**Corrective Action Plan for  
Expanded Bioventing System**

**Site SS-41**

**Former Building 93 (Fuel Pumping Station No. 3)**

**APPENDIX B**  
**REGULATORY COMMENTS AND**  
**RESPONSE TO COMMENTS**

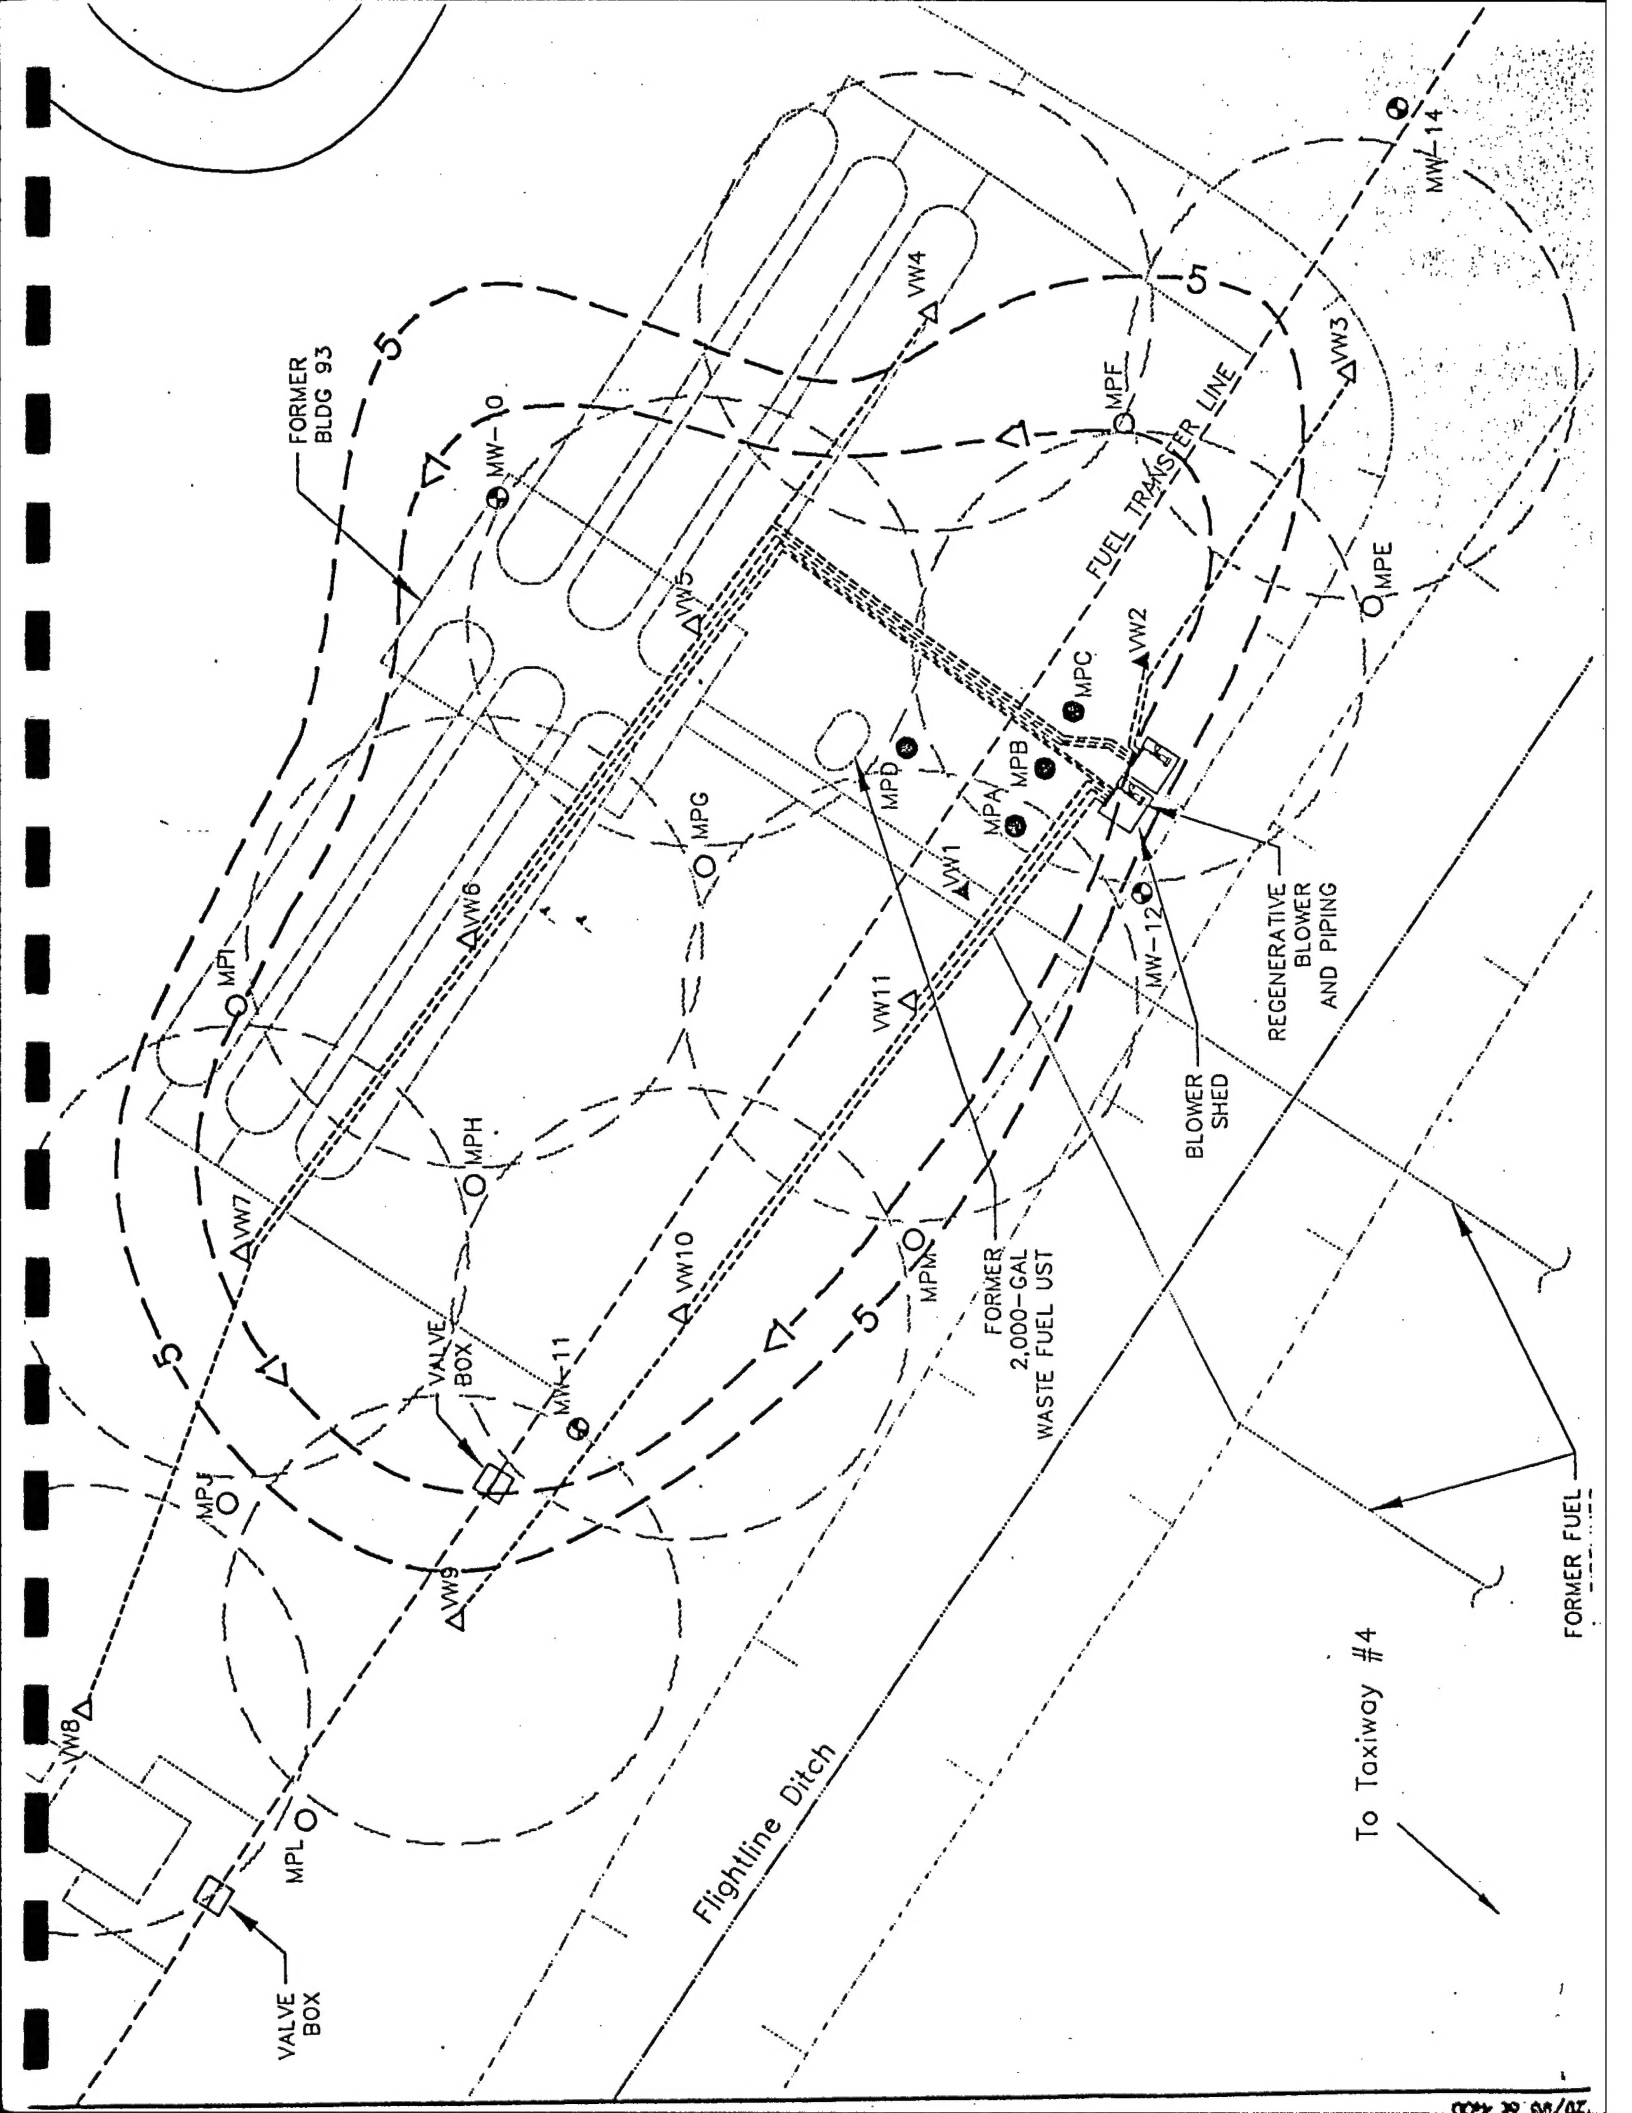
Appropriate reports should be developed incorporating groundwater sampling data, soil sampling data (as available) and system maintenance/monitoring records. These reports should be submitted to my attention subsequent to start-up and very six months thereafter during operation. Appropriate notification should be provided to the Department (my attention) during each major event which requires extended shutdown of the system.

As discussed during our telephone conversation and the above mentioned comment/response, funds are not available to conduct six month sampling of groundwater or soils. Therefore, we cannot produce a six month report. However, start-up reports and post closure reports will be submitted to your attention. Additionally, the Department (your office) will be notified of each major event which requires extended shutdown of the system.

Please refer to Figure 4.1 on page 4-4. Also, see the sketch that is provided as part of this attachment. Groundwater monitoring wells MW-10, MW-11, MW-12 and MW-14 are proposed for groundwater analysis.
